SCHLAGE CYLINDER ASSEMBLY ADDENDUM

FOR REGAL CURVED LEVER (75) TRILOGY MODELS ONLY

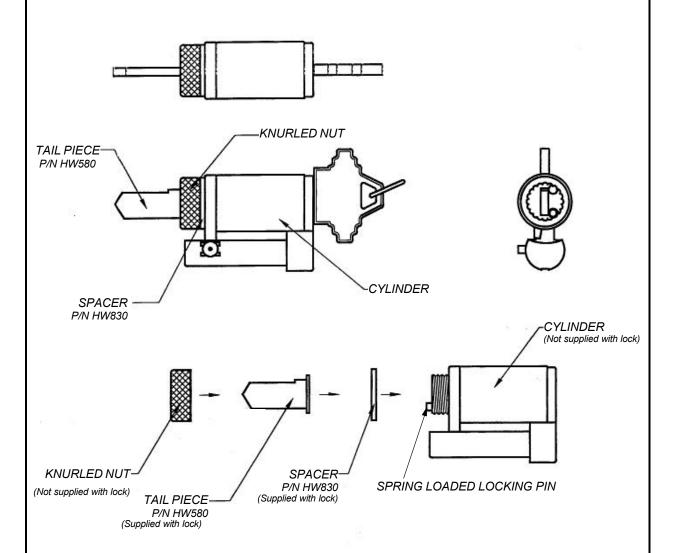
- 1. REMOVE ORIGINAL TAIL PIECE: DEPRESS THE SPRING LOADED LOCKING PIN AND UNSCREW THE KNURLED NUT.
- 2. PLACE SPACER (PROVIDED) ON CYLINDER, AS SHOWN.
- 3. PLACE TAIL PIECE IN VERTICAL POSITION (AS SHOWN).
- 4. ASSEMBLE THE KNURLED NUT: DEPRESS THE SPRING LOADED LOCKING PIN, THEN SCREW BACK ON THE KNURLED NUT.
- 5. CHECK FOR PROPER CLEREANCE FOR ROTATION OF THE CYLINDER AND MAKE SURE THAT THE SPRING LOADED PIN IS LOCKED WITH THE NUT.
